Product / Process Change Notification (PCN)

PCN #: PCN_IndCMB_20230703
Affected Series: WE-CMB-Series; 744821xxx, 744822xxx
 744823xxx, 744824xxx, 744825xxx
 744826xxx and customized parts
PCN Date: April 03, 2023
Effective Date: July 03, 2023

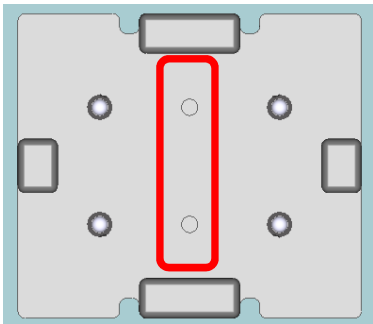
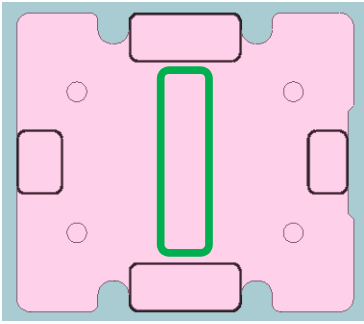
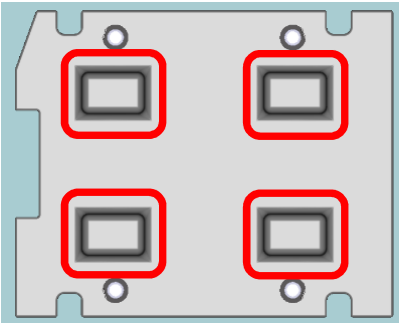
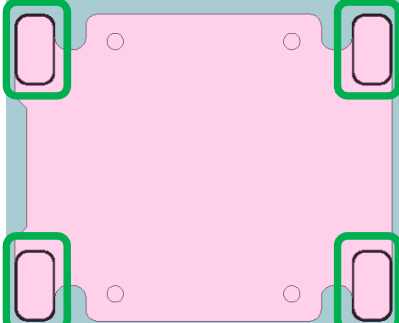
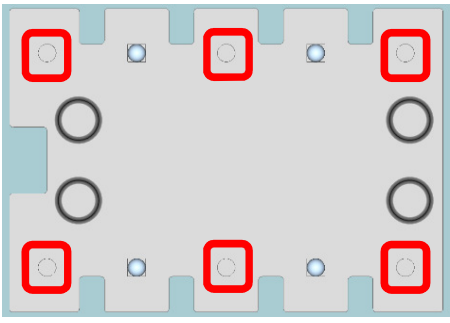
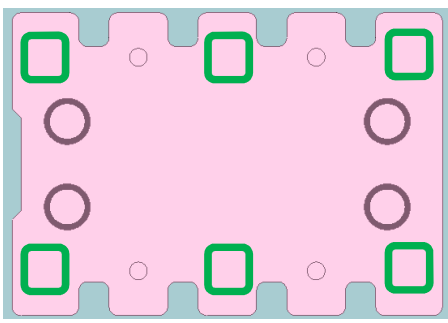
Würth Elektronik will change the current base plate design and invest into new tooling to improve the processability.

With the new design we will close all empty holes on the base plates, which are not necessary for the windings and have no function. This concerns all bases where the pins are injected in the base plate. Bases with winding ends as direct pins are not affected. The change affects the sizes S, L and XL. For size M we will change the position of the standoffs.

Detail of Change:

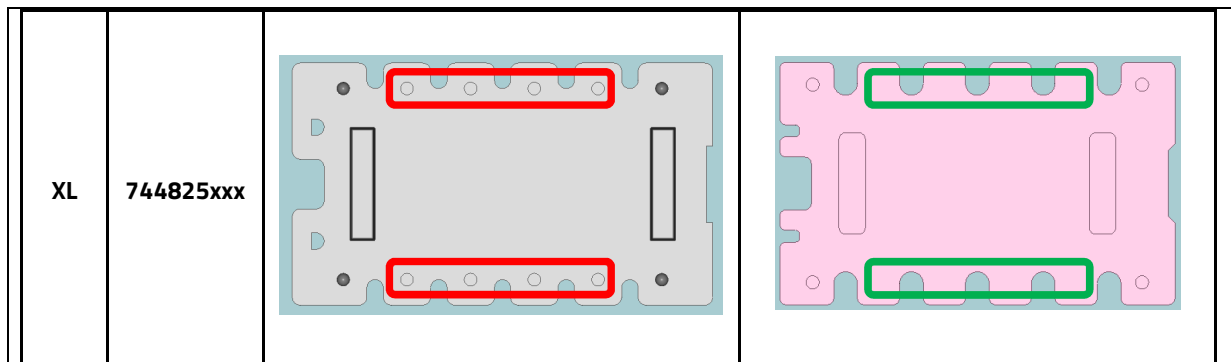
According to the new requirement of standard IEC 60938-2 we will add the tolerance of the specified inductance in the label.
